Title: G E HIGH VOLTAGE STARTERS

Number: C8702

PRODUCT SERVICE BULLETIN

**SUBJECT- SAFETY ALERT!
LIMITAMP SHUTTER ROLLER SHAFT**

FIG. A
SHUTTER ROLLER SHAFT

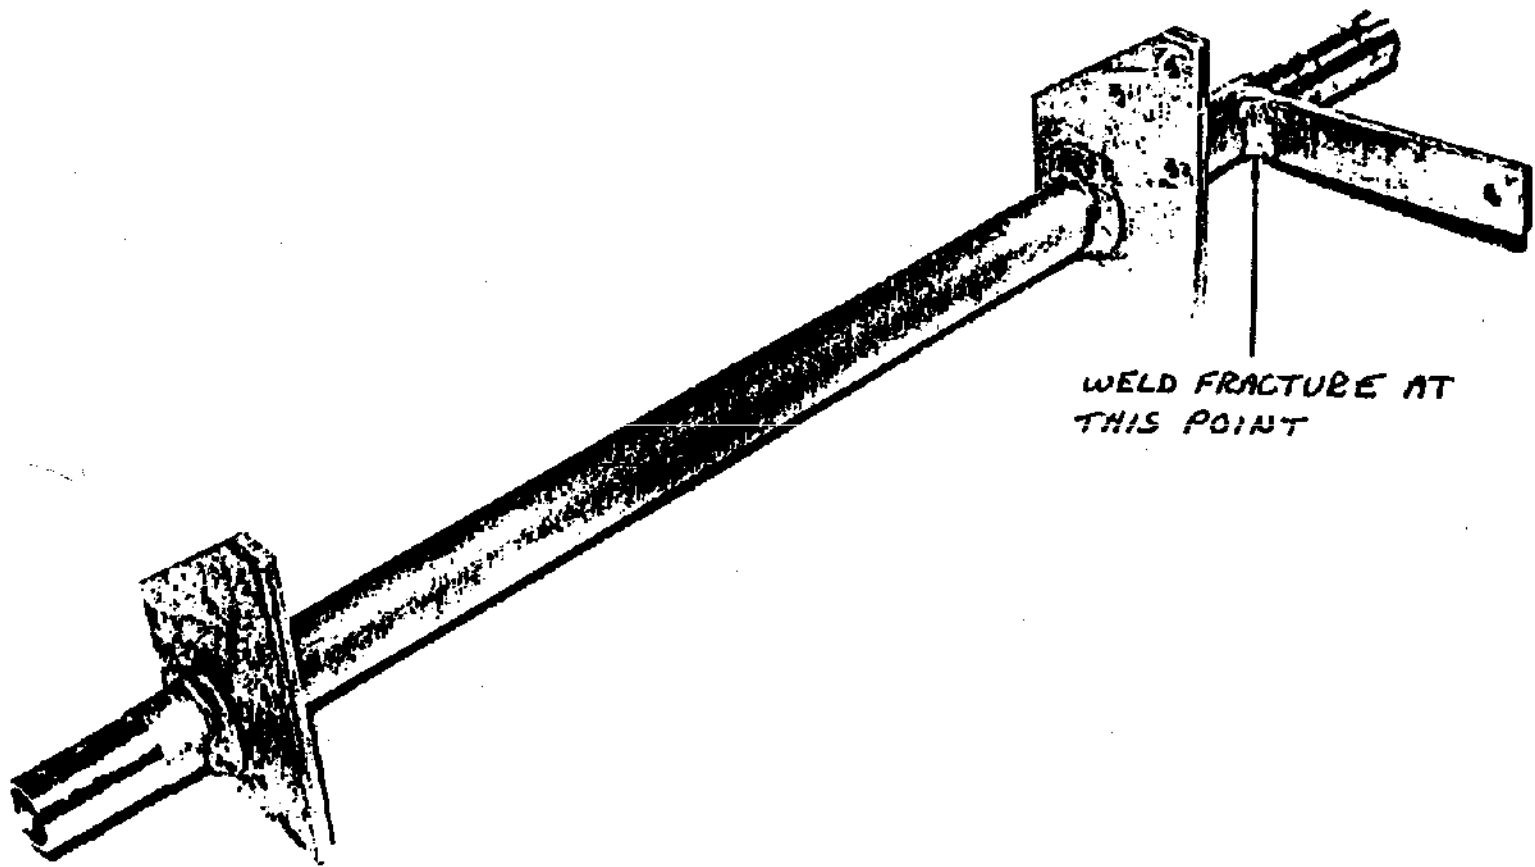
We have had two isolated reports of the breakage of a mechanical interlock in Limitamp starters built during the above time period allegedly resulting in an electrical hazard to an operator when inserting a Limitamp contactor into its compartment. The attached Picture (Figure A) shows the detail of the part and the mode of breakage.

The cause of the failure in these incidences has been identified as a poor weld (cold) resulting in insufficient weld bond joining the lever arm to the shutter roller shaft. We changed our design and increased the welding area over two years ago so only units shipped prior to '83 with date codes AM to DW may be affected. Date codes can be located on a sticker inside the low voltage door.

WELD FRACTURE AT
THIS POINT

Upon notification of any significant variance we will supply new shutter roller shaft at no charge to the customer for installation.

FIGURE B

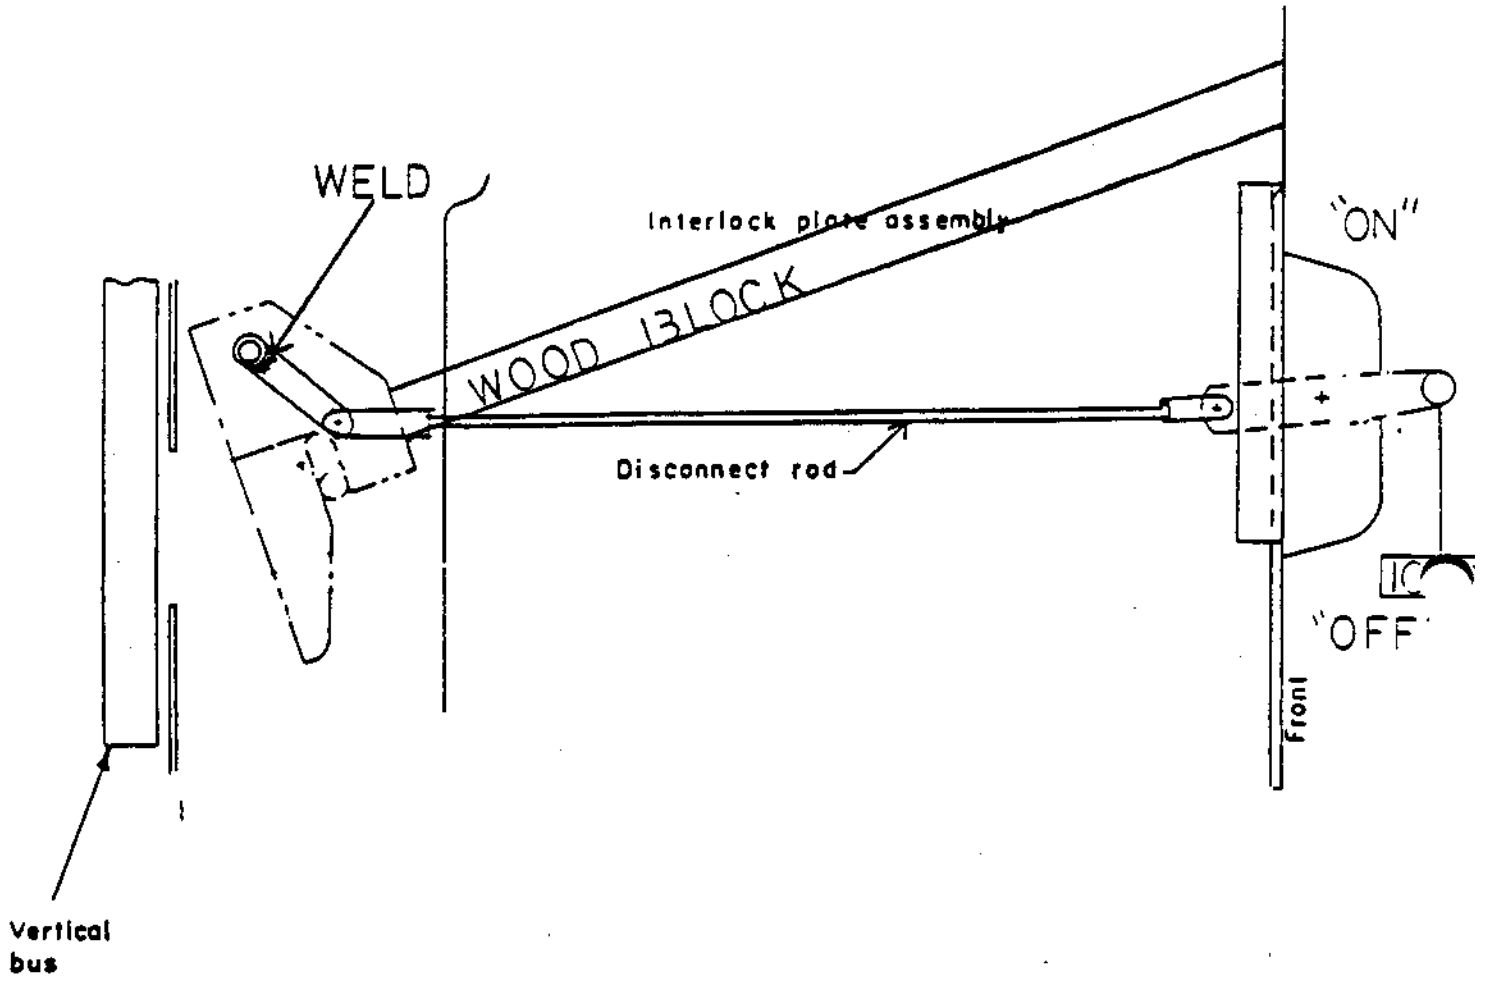
- 3) Rotate the handle to a mid position; jam the mechanism by inserting a wooden brace between the cam and handle as illustrated in Fig. (B). With a small amount of pressure applied to the handle, measure the distance from the handle to the floor; then, apply a 100 pound weight to the handle; remove the weight and with a small amount of handle pressure, remeasure the handle position. Both measurements should be essentially the same.

- 4) If a significant variance is found (e.g. .25") do not reinsert the contactor and contact your G.E. Representative or the Mebane Factory Product Service, P.O. Box 489, Mebane, N.C. 27302, ATTN: R.C. Roessler, Jr., or call (919) 563-7367.
